RENESAS TECHNICAL UPDATE

Product Category	MPU & MCU	Document No.	TN-RX*-A113A/E	Rev.	1.00
Title	Corrections to Descriptions for the Flash Memory in the RX110 Group User's Manual		Information Category	Technical Notification	
Applicable Product	RX110 Group	Lot No.	Reference Document	RX110 Group User's Manual: Hardware Rev.1.00 (R01UH0421EJ0100) Specification Changes to the RX110 Group (TN-RX*-A112A/E)	
		All

This document describes corrections to 31. Flash Memory in RX110 Group User's Manual: Hardware Rev.1.00.

Figure 31.3 Area Protection Overview

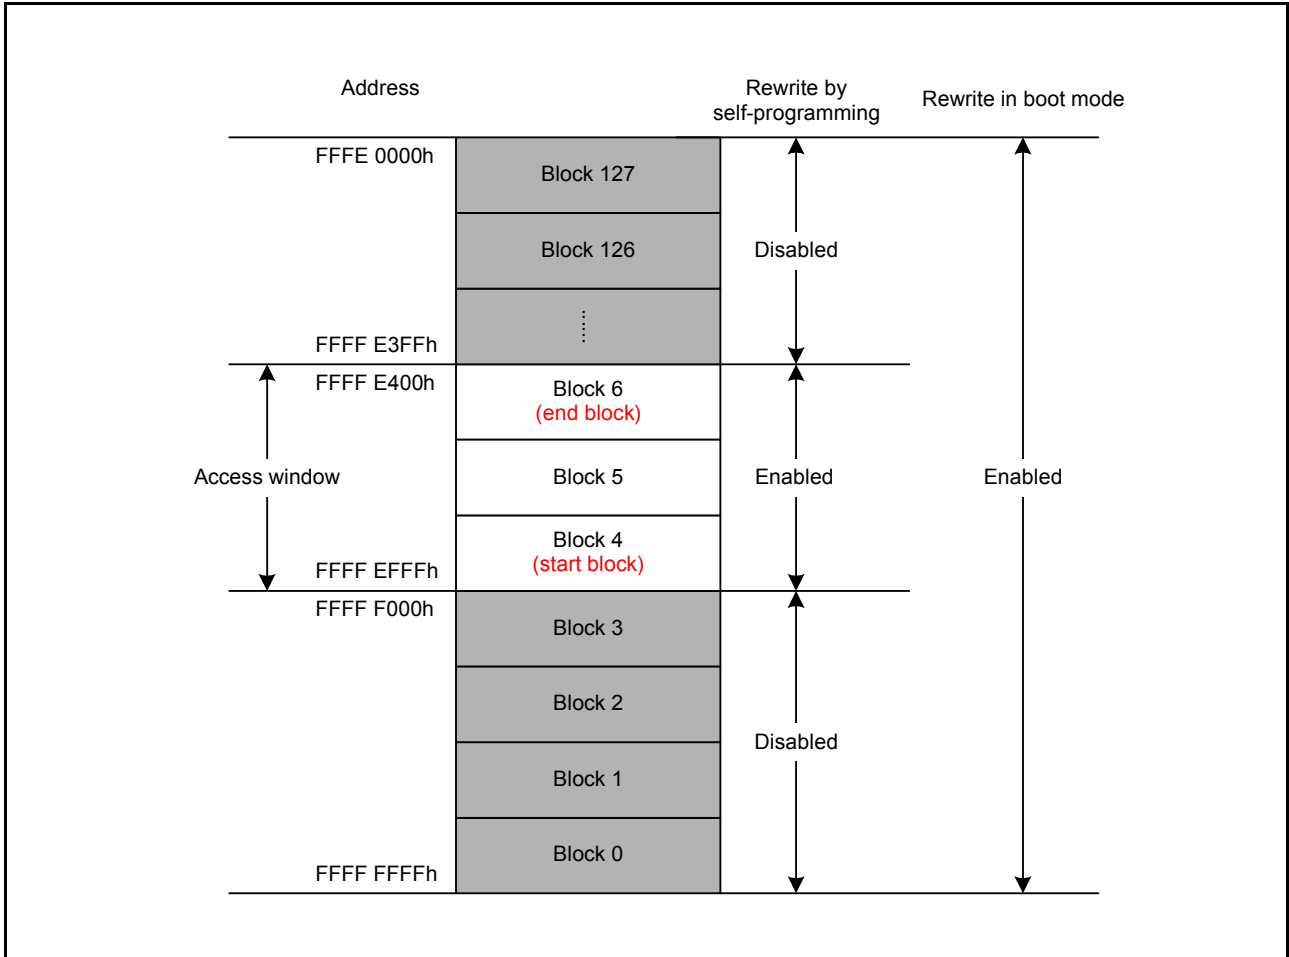
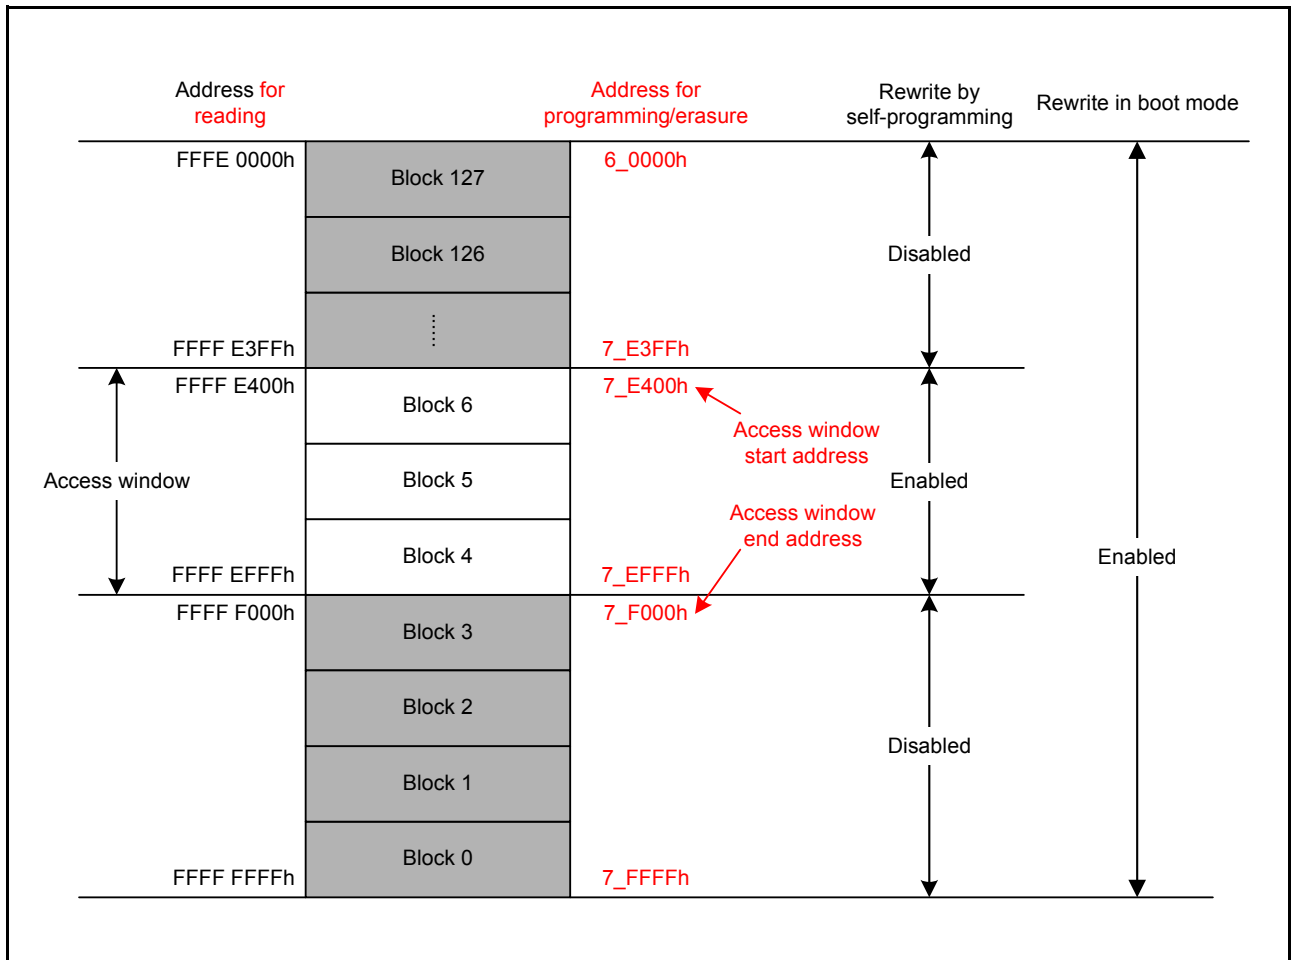
Description in 31.5 Area Protection and Figure 31.3 are changed as follows:

Select the start **block** and end **block** to set the access window. While the access window can be set in boot mode or by self-programming, area protection is enabled only during self-programming in single-chip mode.

Specify the start address and end address to set the access window. While the access window can be set in boot mode or by self-programming, area protection is enabled only during self-programming in single-chip mode.

Figure 31.3 Area Protection Overview (Set Blocks 4 to 6 as the Access Window)

Figure 31.4 Mode Transitions of the Flash Memory

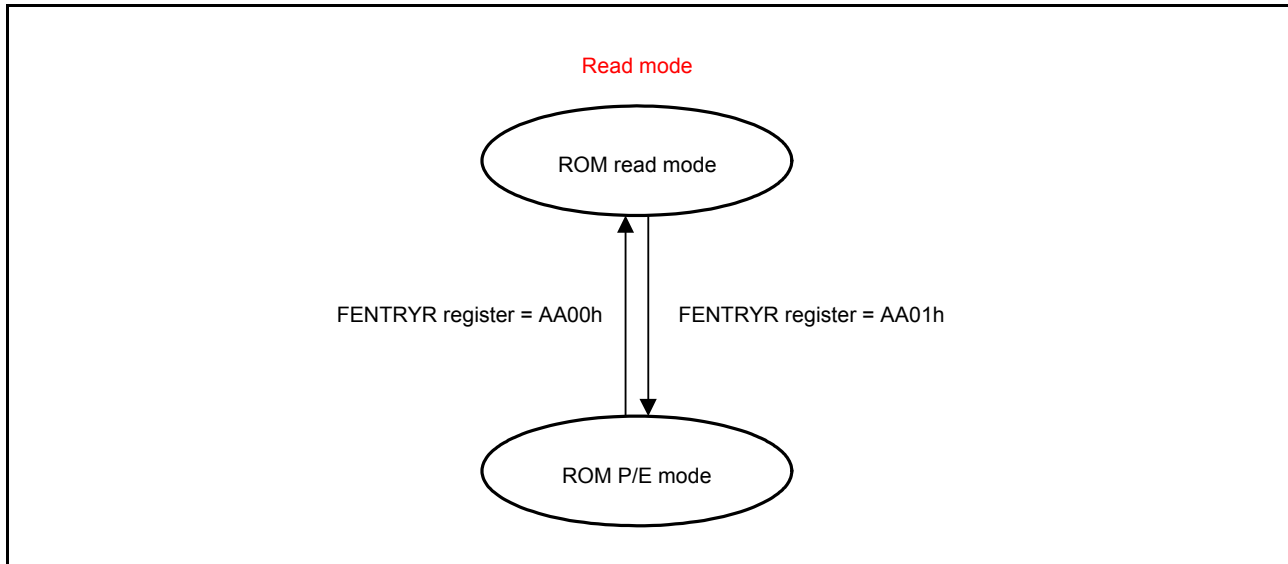
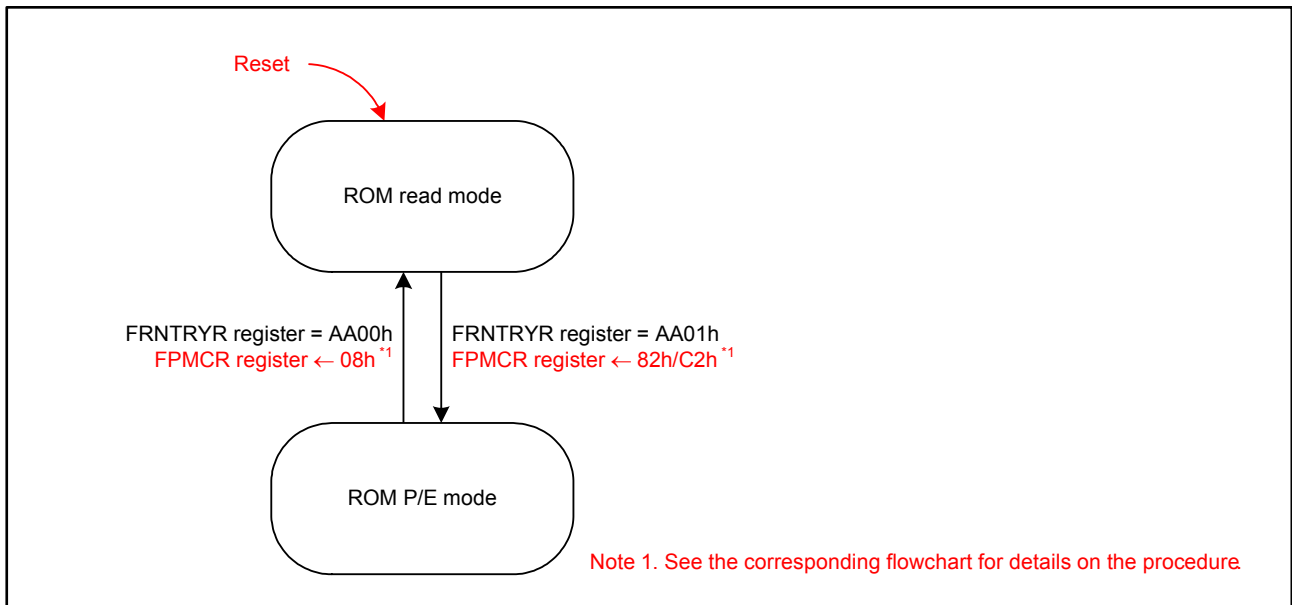
Description in 31.6.1 Sequencer Modes and Figure 31.4 are changed as follows:

The sequence has **three** modes. Transitions between modes are caused by writing to the FENTRYR register **or issuing commands**. Figure 31.4 is a diagram of mode transitions of the flash memory.

The sequencer has 2 modes. Transitions between modes are caused by writing to the FENTRYR register and setting the FPMCR register. Figure 31.4 is a diagram of mode transitions of the flash memory.

Figure 31.5 Procedure for Transition from ROM Read Mode to ROM P/E Mode

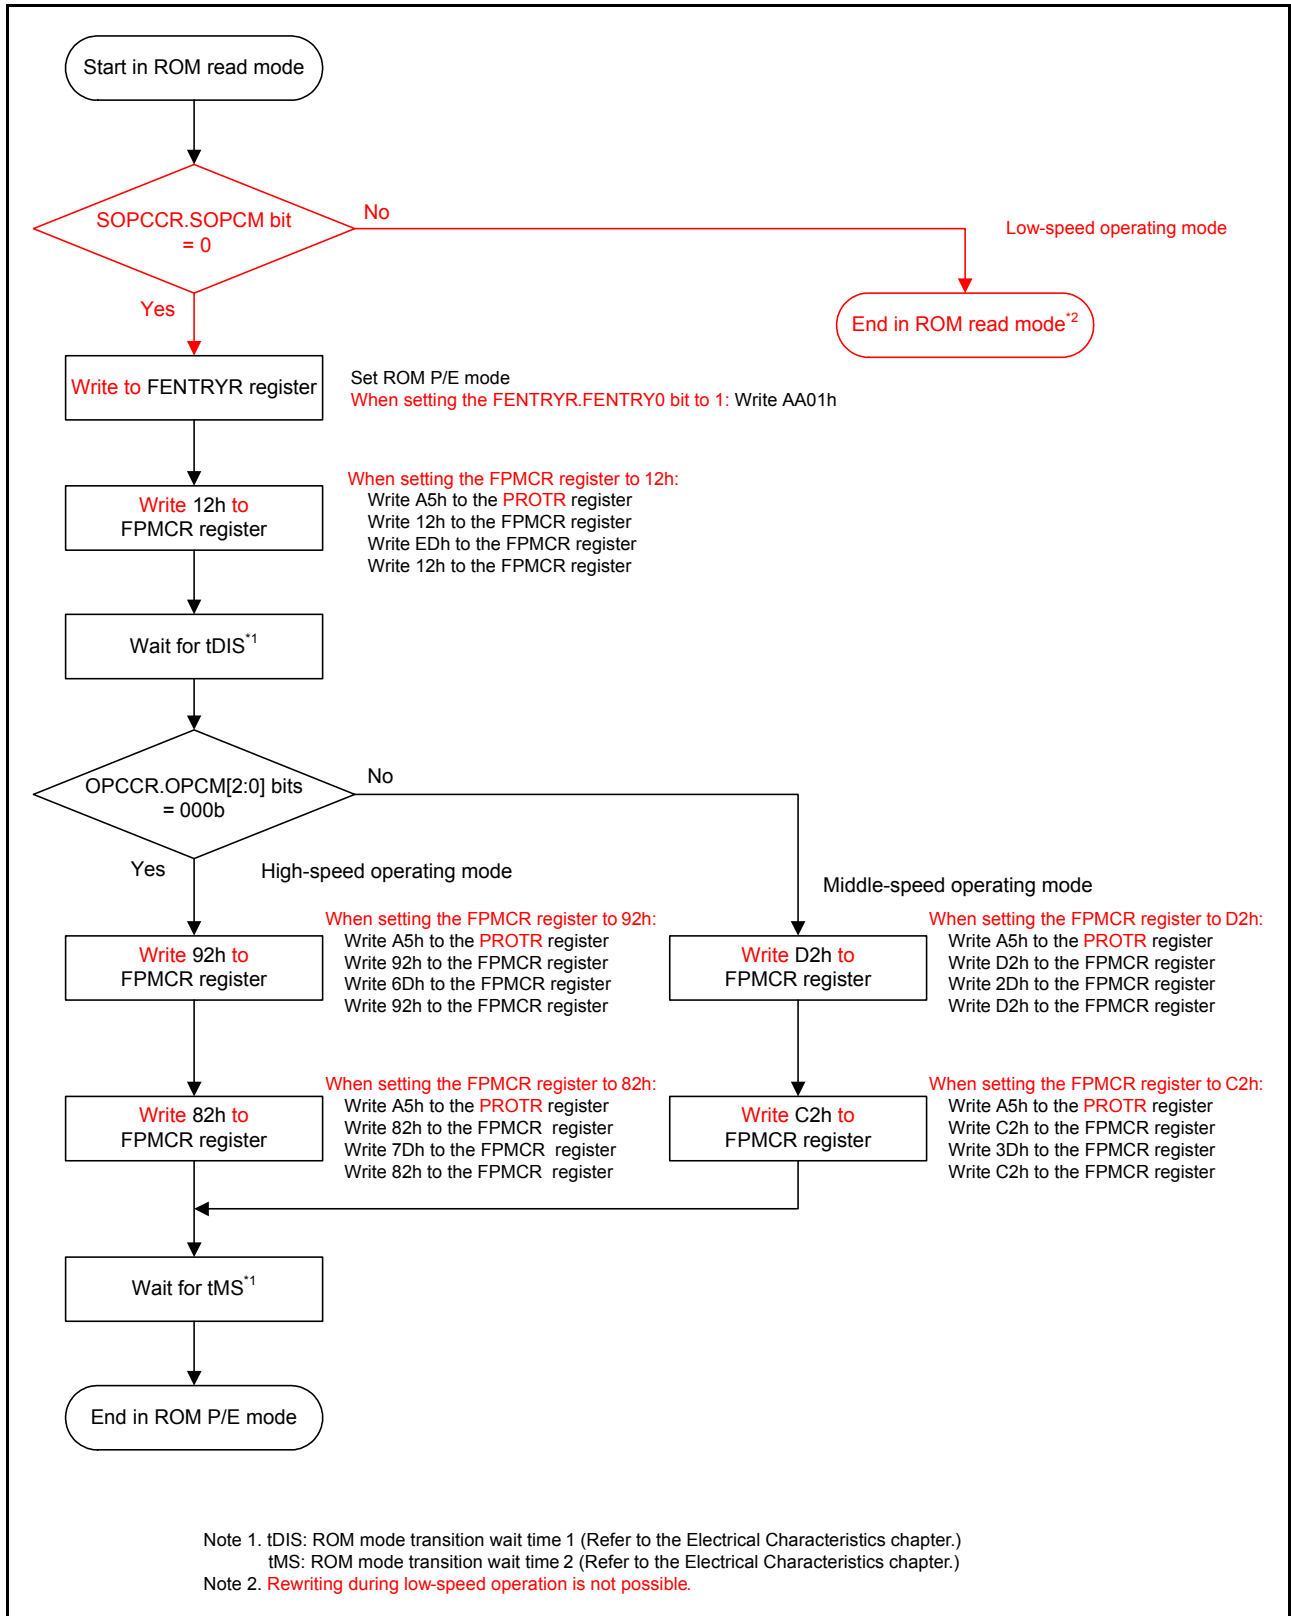
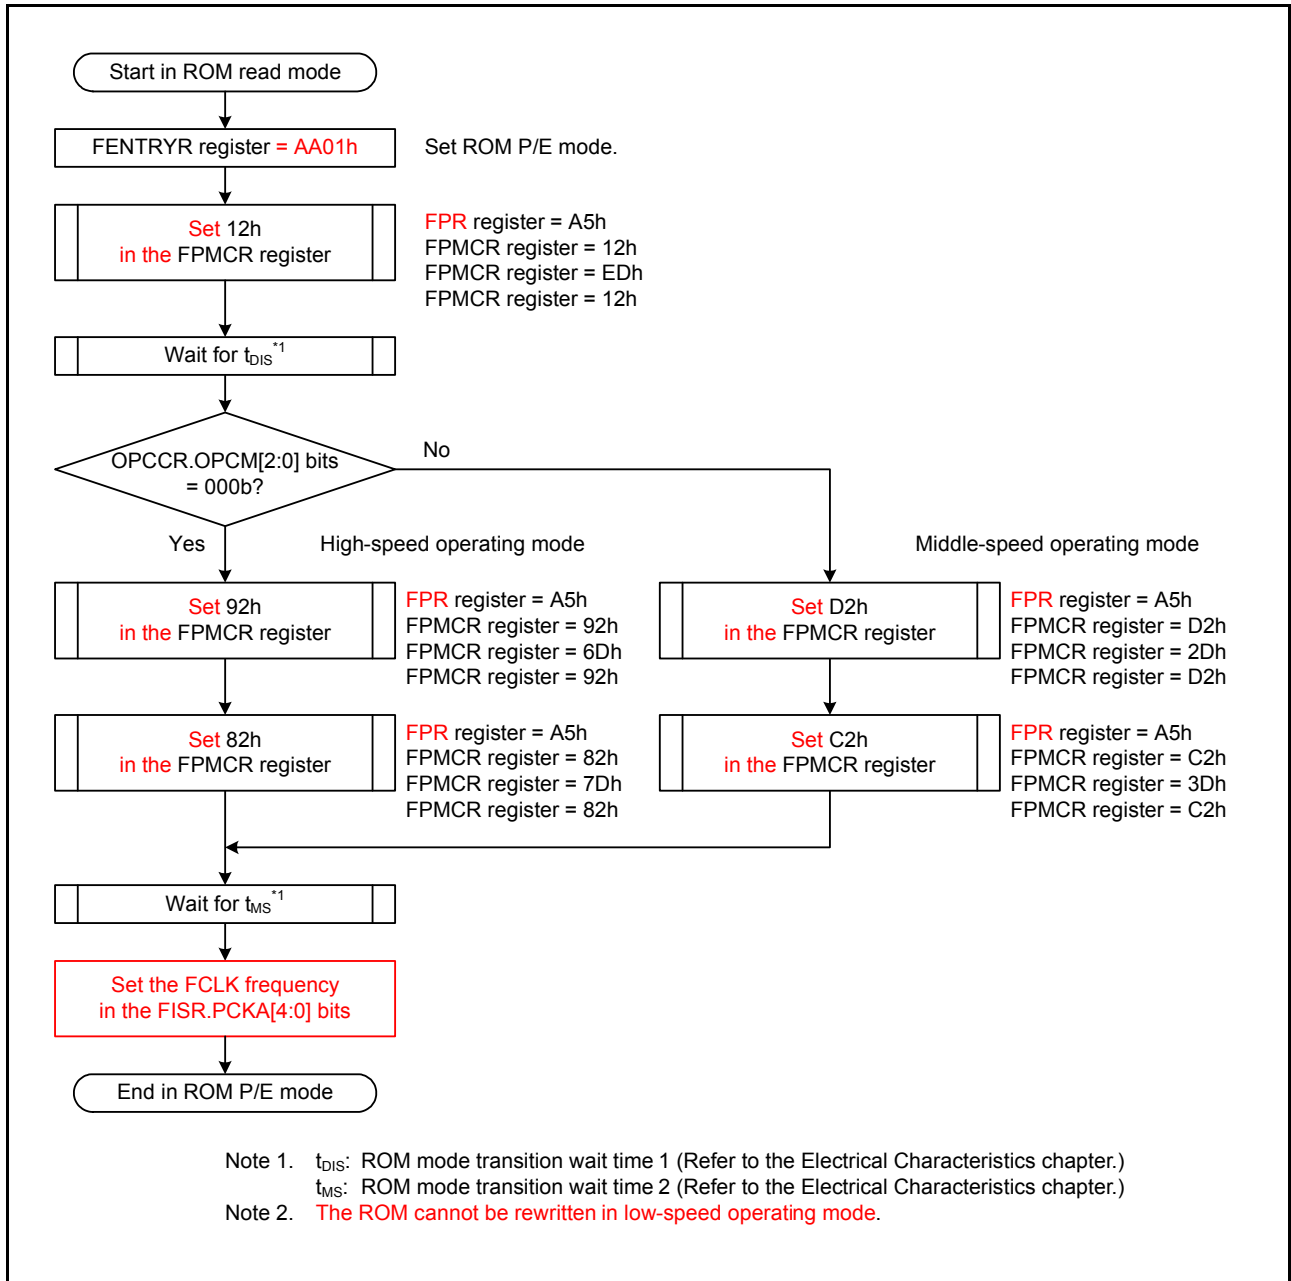
Figure 31.5 in (1) Switching to ROM P/E Mode of 31.6.3 Software Command Usage is corrected as follows:

Figure 31.6 Procedure for Transition from ROM P/E Mode to ROM Read Mode

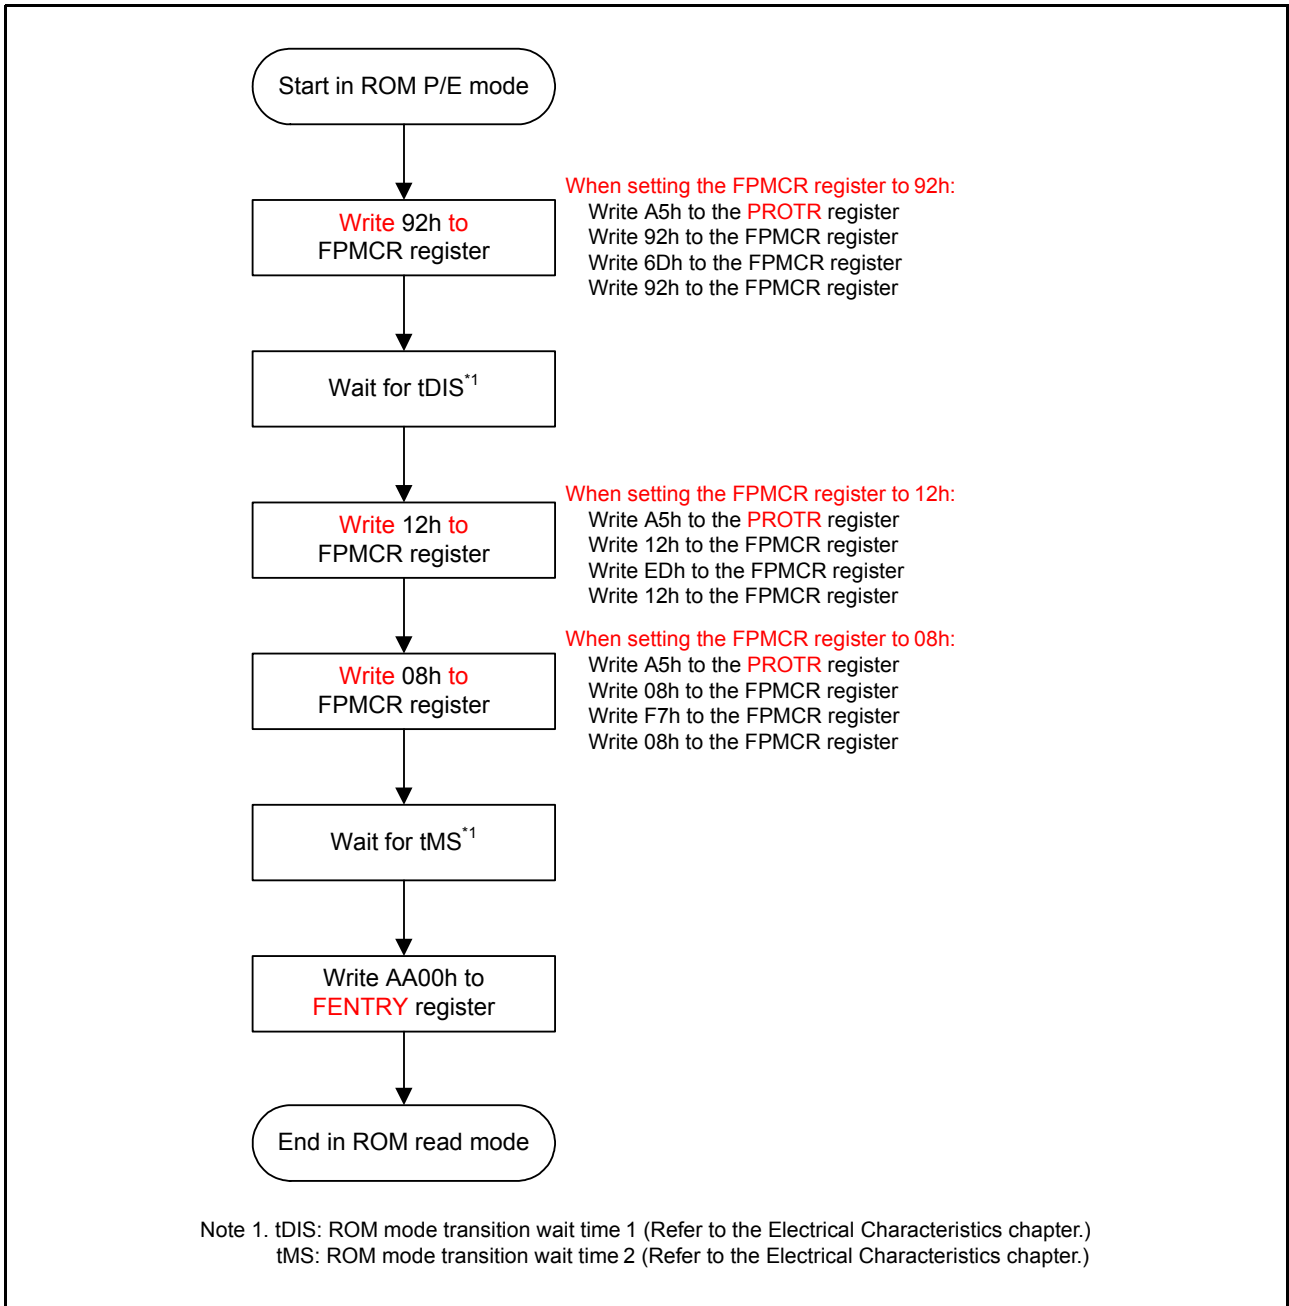
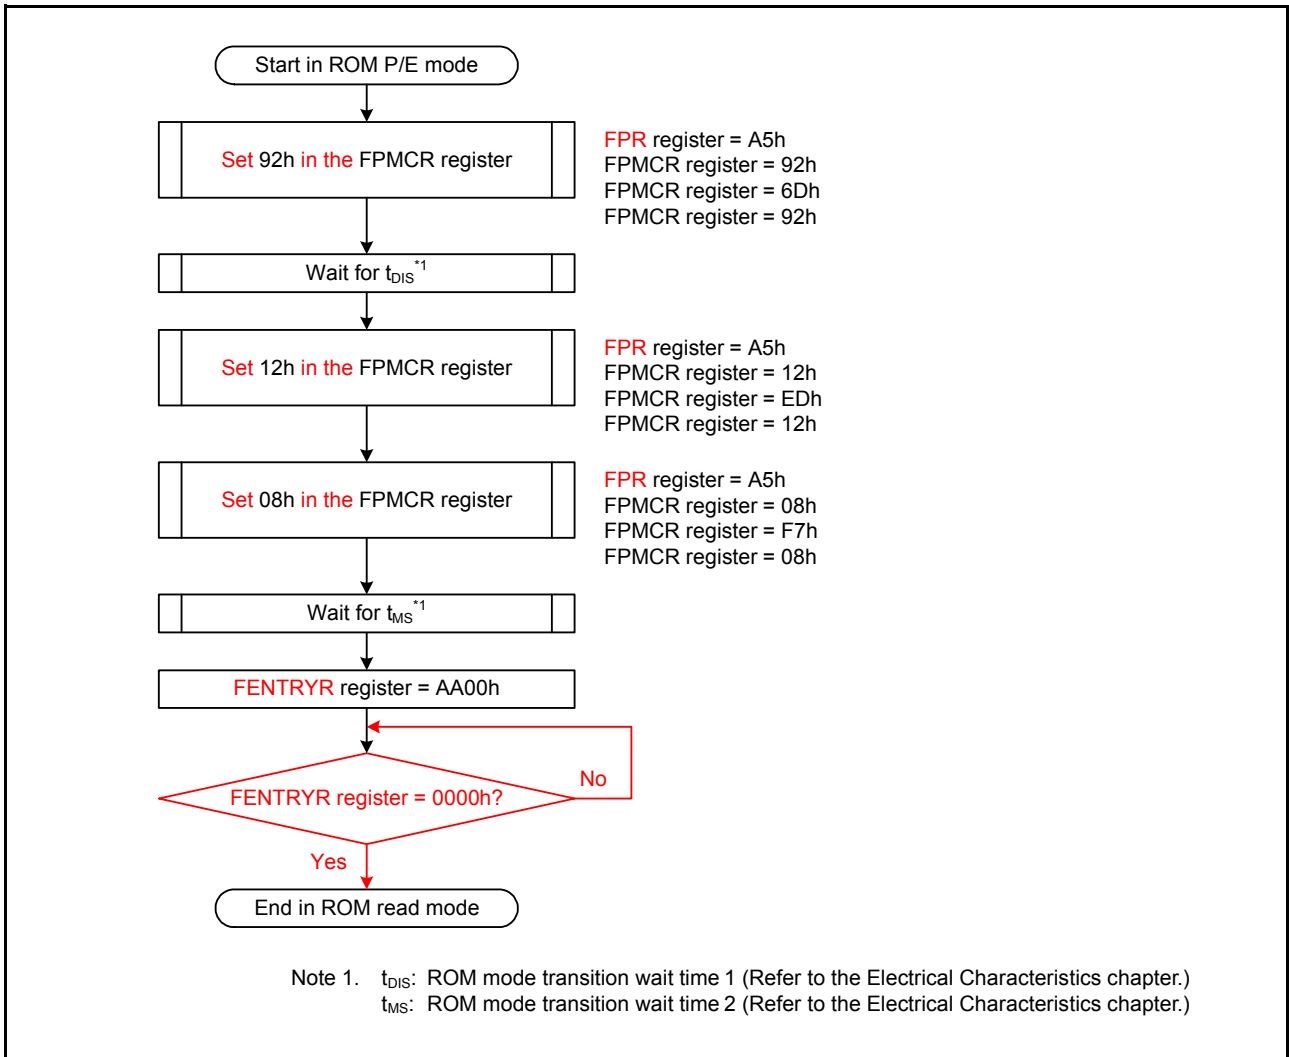
Figure 31.6 in (2) Switching to ROM Read Mode of 31.6.3 Software Command Usage is corrected as follows:
